Product Change Notice (PCN)

PCN Number: PCN-0451110R-01

Product(s) Affected: PJ-017D

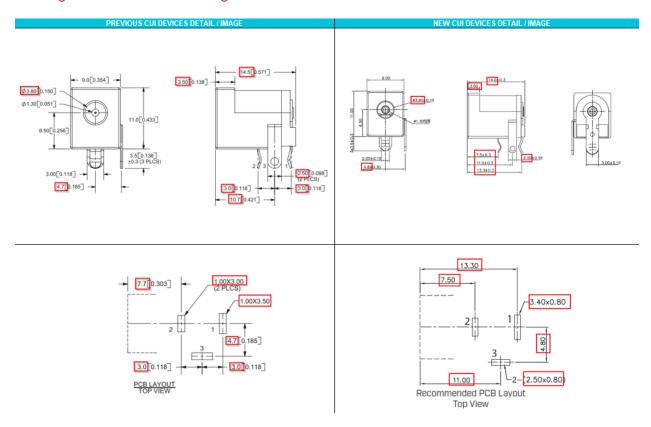
Description of Change: Minor Housing and footprint differences. Material Change on the housing and terminals. See image Below

PREVIOUS CUI DEVICES DETAIL / IMAGE			
	MATERIAL	PLATING	
center pin	copper	nickel	
terminal 1	brass	silver	
terminal 2	copper alloy	silver	
terminal 3	brass	silver	
plastic	PBT

NEW CUI DEVICES DETAIL / IMAGE			
DESCRIPTION	MATERIAL	PLATING/COLOR	
center pin	brass	nickel	
terminal 1	brass t=0.40	silver	
terminal 2	bronze t=0.30	silver	
terminal 3	brass t=0.40	silver	
cover	PA9T (UL94V-0)	black	
housing	PA9T (UL94V-0)	black
